ADDENDUM NO. 1

February 16, 2024

Yorktown High School – Addition and Renovations 1100 South Tiger Drive Yorktown, IN, 47396

ADDENDUM

NG NO.: C500

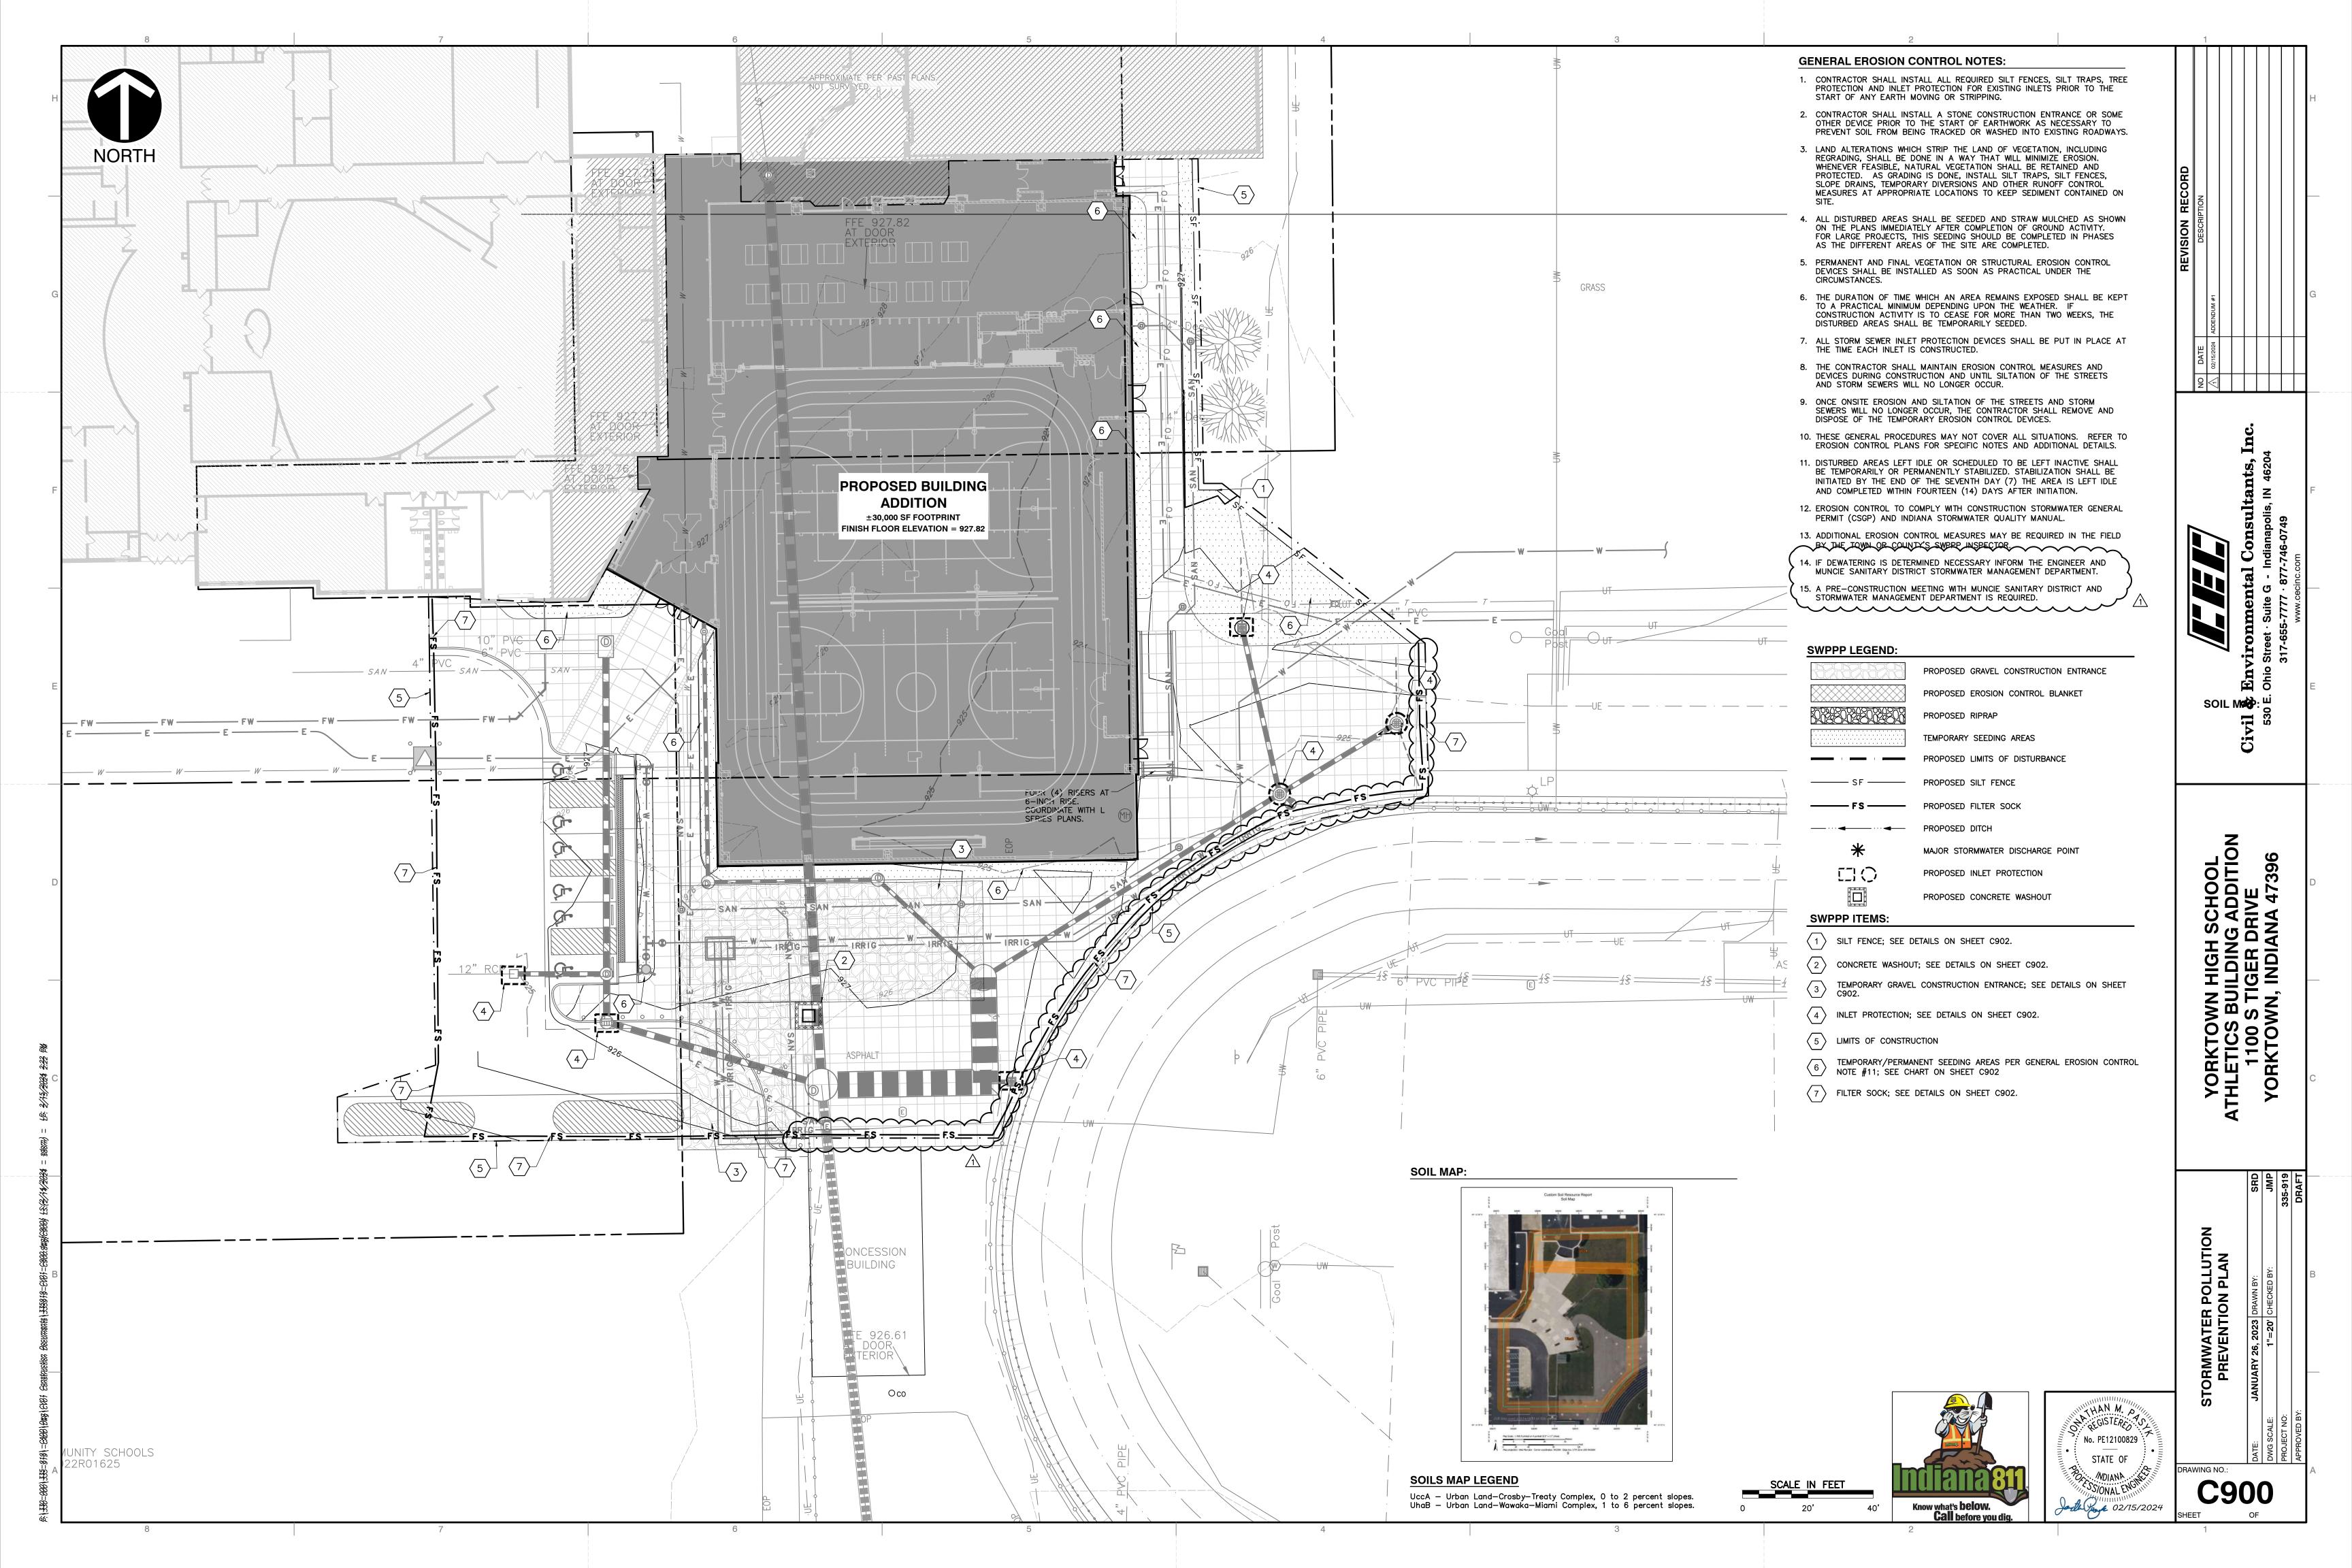
A. Added City and Utility Contacts note.

DRAWING NUMBER S202J

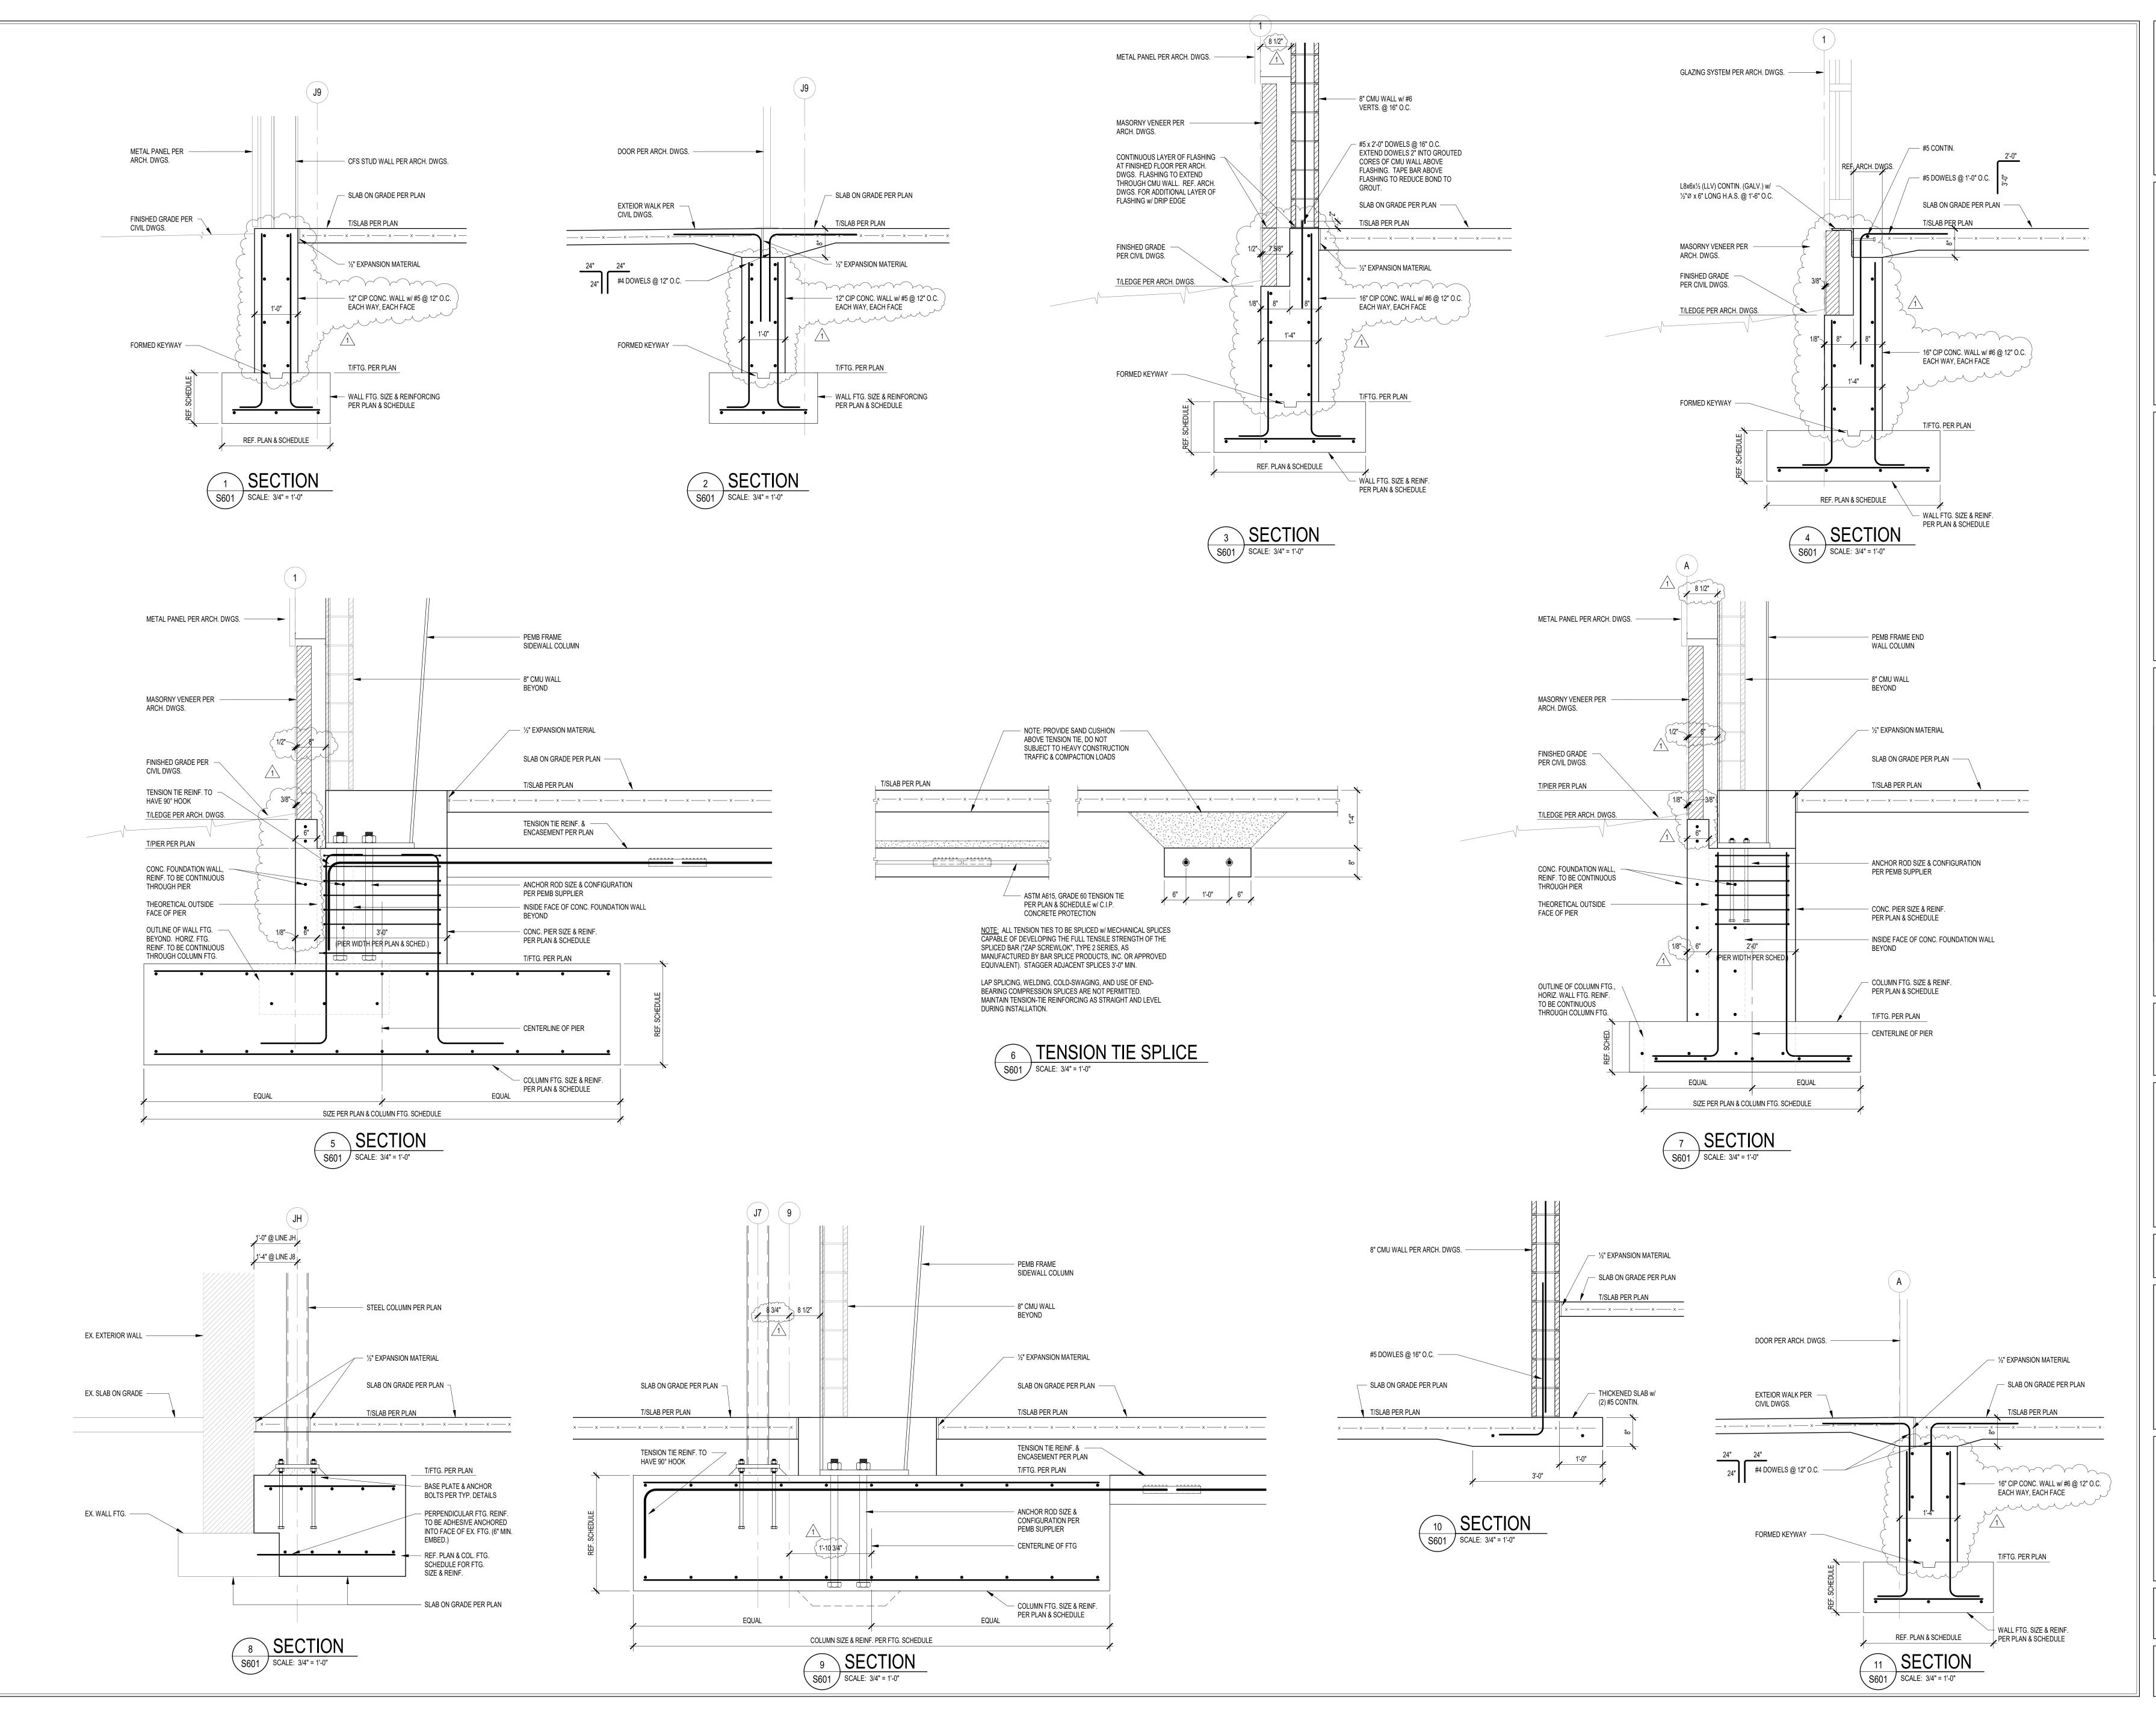
3.16 S202J – LOW ROOF / MEZZ FLOOR FRAMING PLAN – UNIT J

- A. Dimensions around the new southwest entry have been revised to better accommodate the existing skewed exterior wall as shown on the attached drawing.
- B. Dimensions to the PEMB Building Lines have been adjusted as shown on the attached drawing.
- C. Column lines J4.3 & J5.0 have been moved south 10' and renamed J3.8 & J4.3 as shown on the attached drawing.

> DRAWING TITLE: FIRST FLOOR LIFE SAFETY PLAN

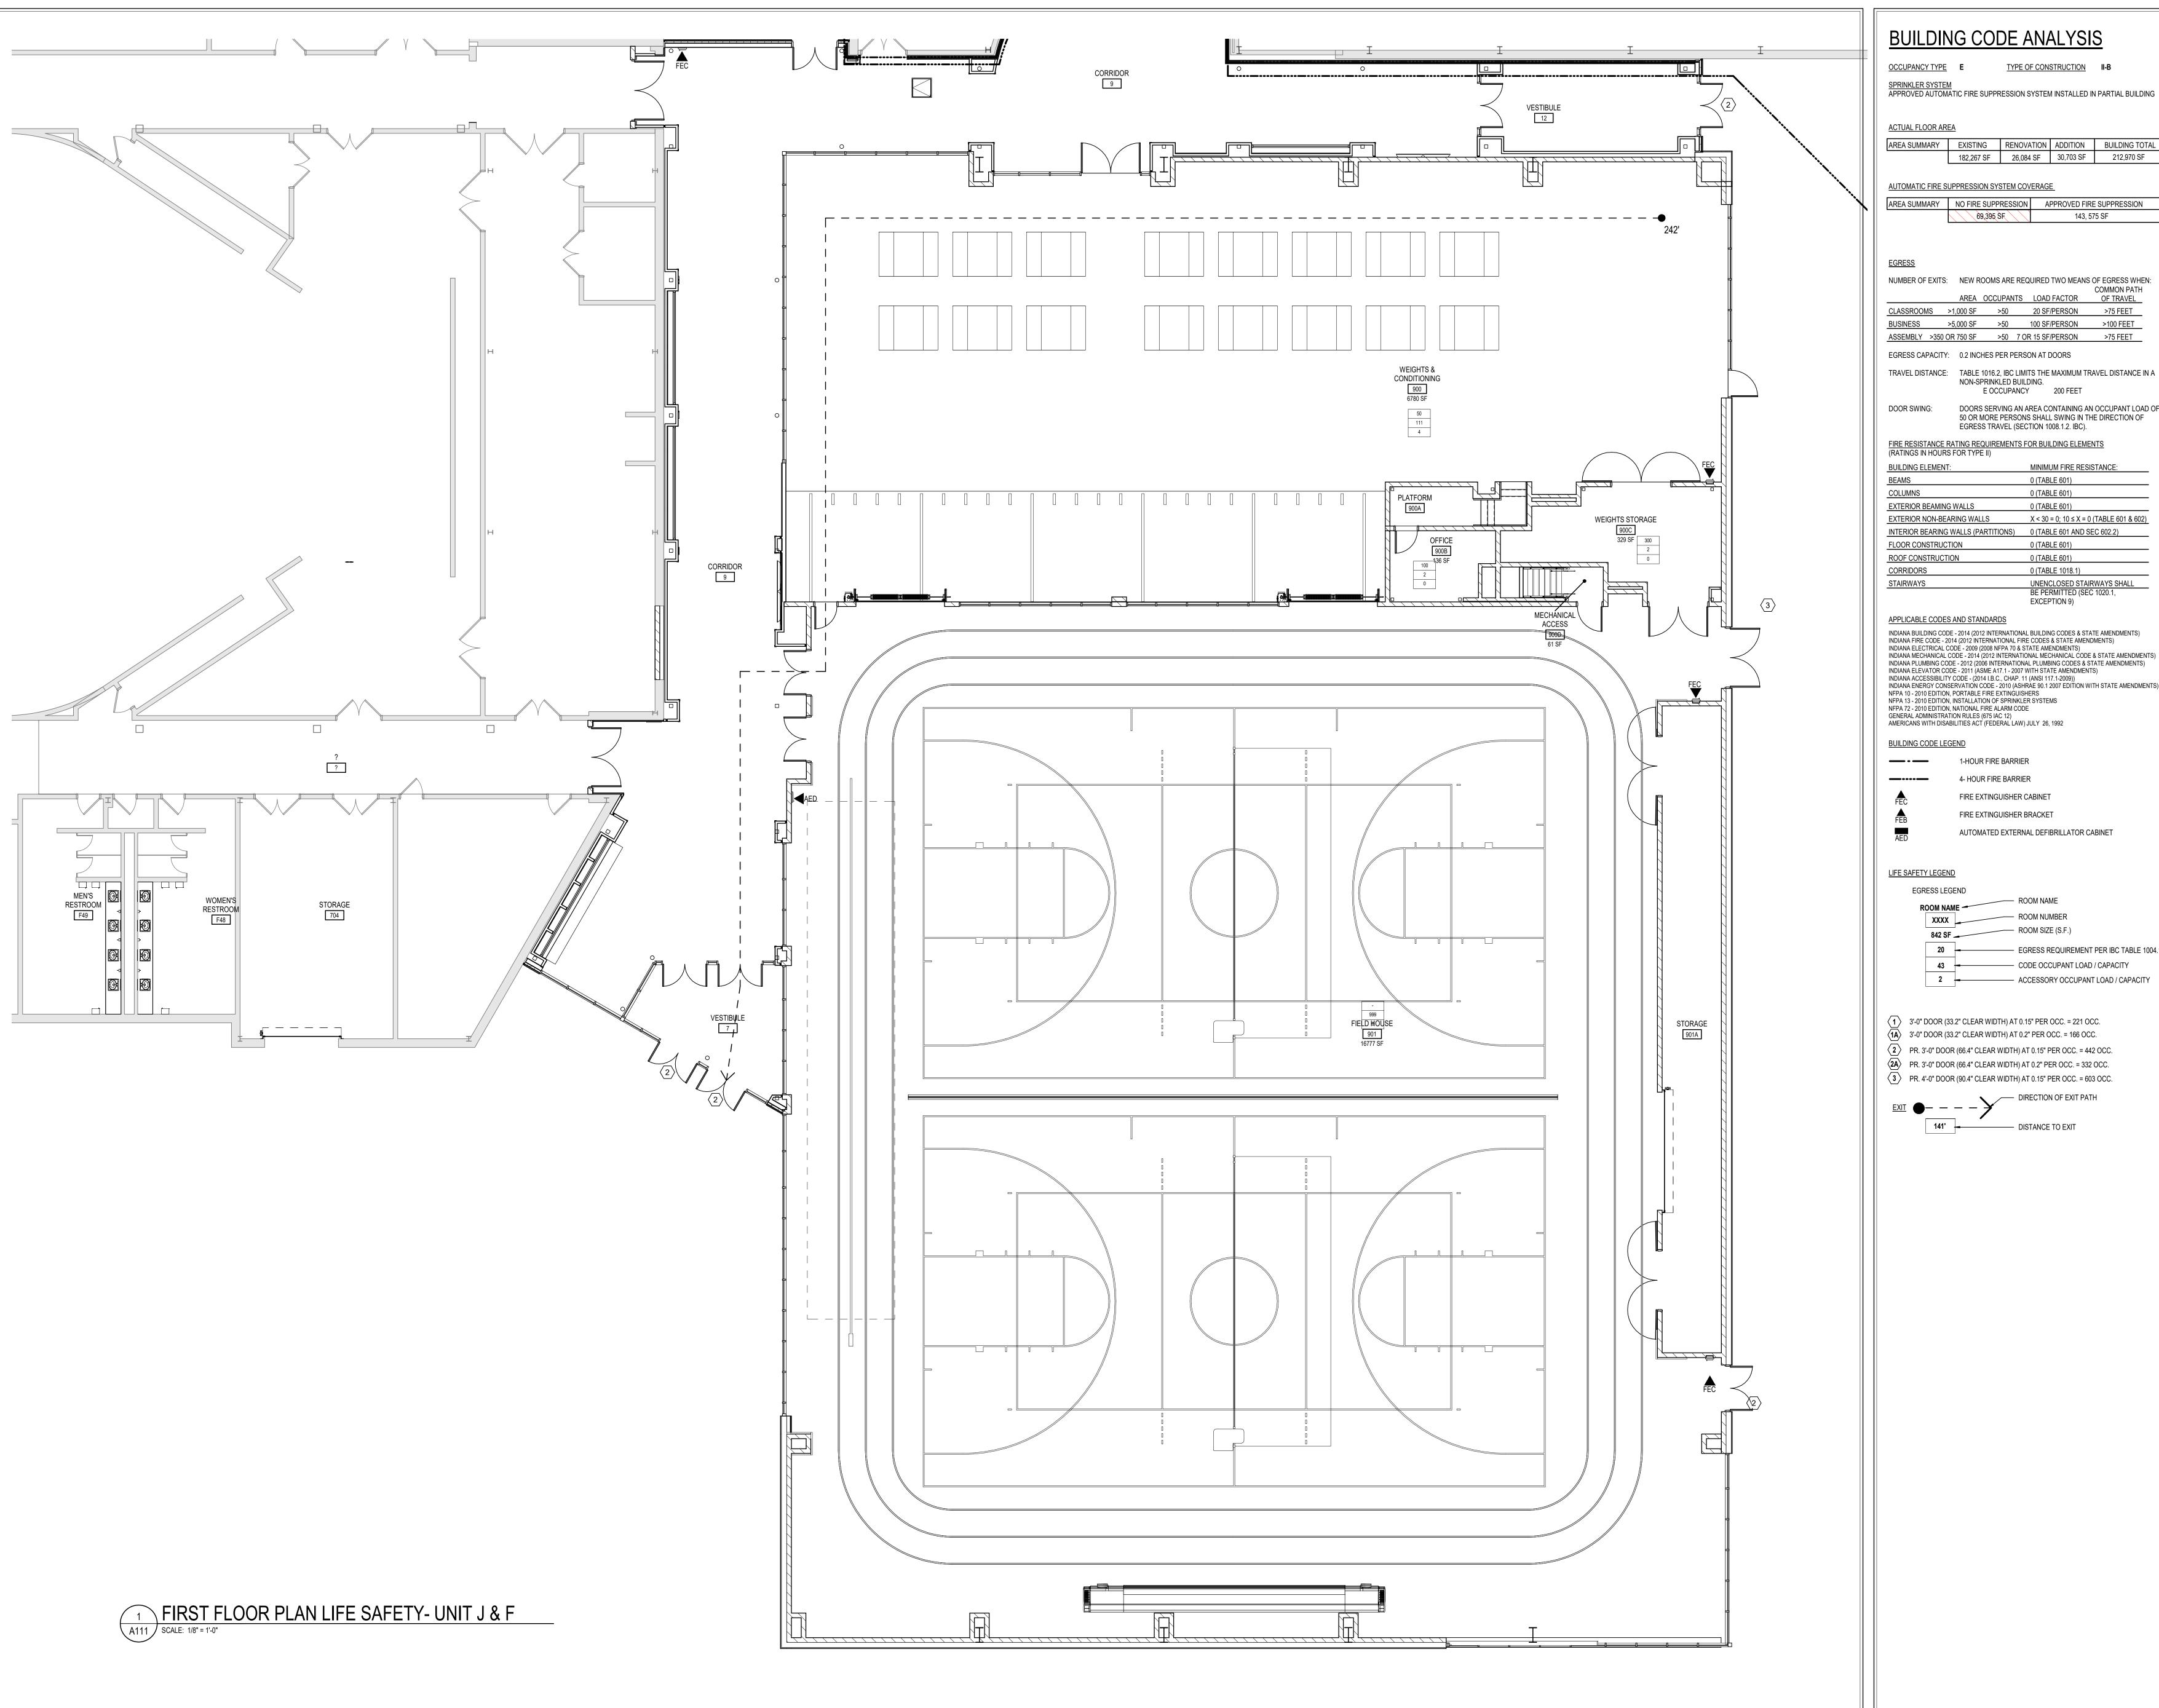
3.1 <u>A110 – FIRST FLOOR LIFE SAFETY PLAN</u>
